NOV_SCE_MYU_ 20220224-01

NOTICE OF VIOLATION

Energy Safety Inspection Report

Report Name: NOV_SCE_MYU_20220224-01
Date(s): February 24, 2022
Inspector: Matthew Yunge
Utility: Southern California Edison
Attention: Erik Takayesu, Vice President Asset Strategy and Planning

Structure ID: 1896709E

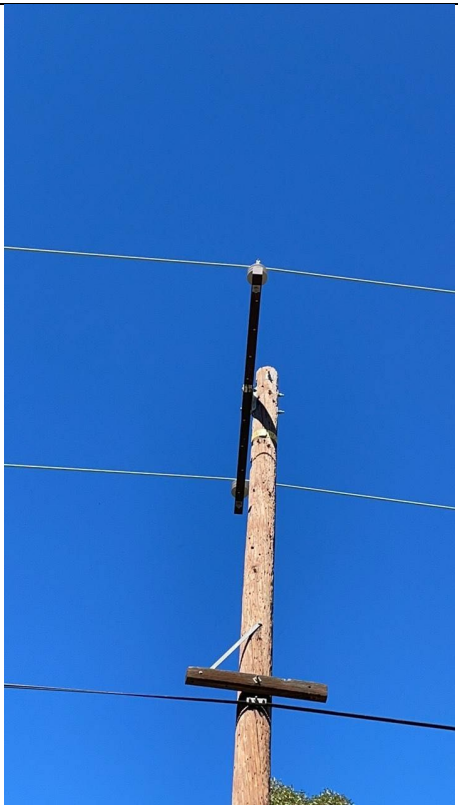
Item1IA1Img1: No vibration dampers installed

Structure ID: 1896708E

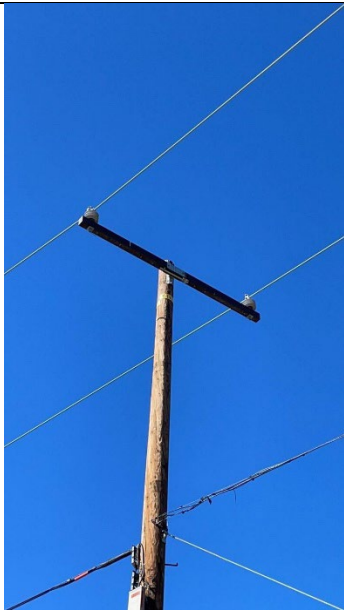
Item2IA1Img1: No vibration dampers installed
